Service Manual

74CD53/21B/22B/25B/21G/22G
74CD63/21B/22B/25B
CD-63MKII U, F

Compact disc player

model CD-53MKII / CD-63MKII

SCHEMATIC DIAGRAM

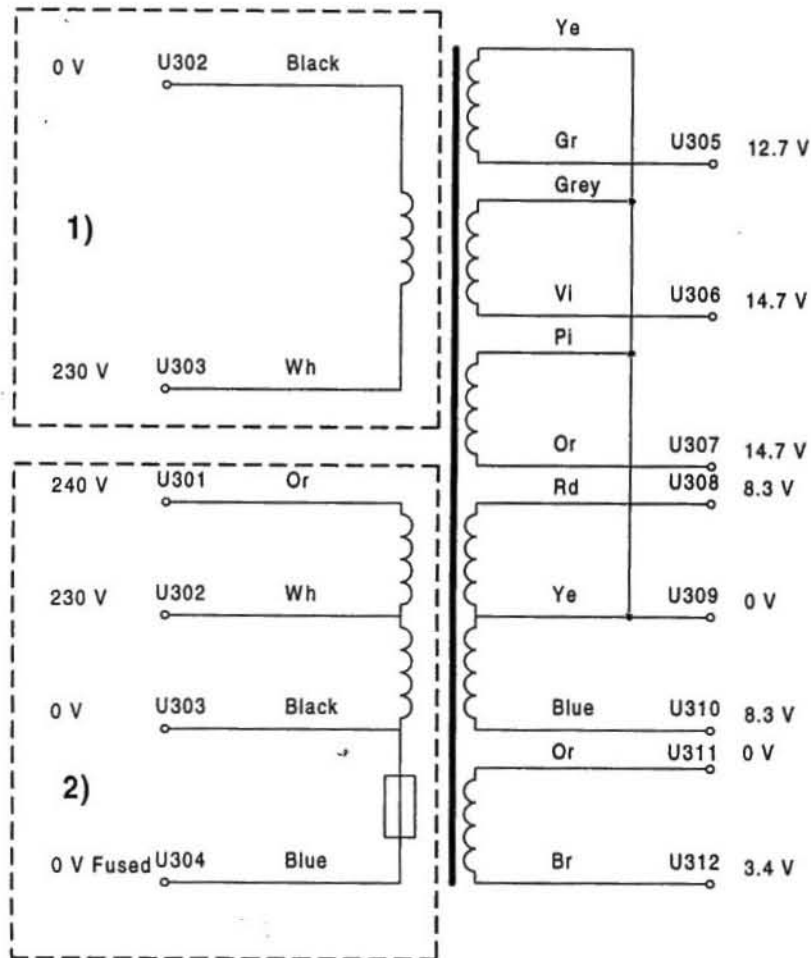
This service manual gives the electrical differences between the CD63MKII (CD63/22/25) and the CD63KI (CD63/92/95).

POS. NO	PART NO.	DESCRIPTION
L001	4822 146 10377	TRANSFORMER (I92/95)

1) Primary winding for sets with yellow dot on serial number label.

2) Primary winding for sets with blue, red, green or white dot on serial number label
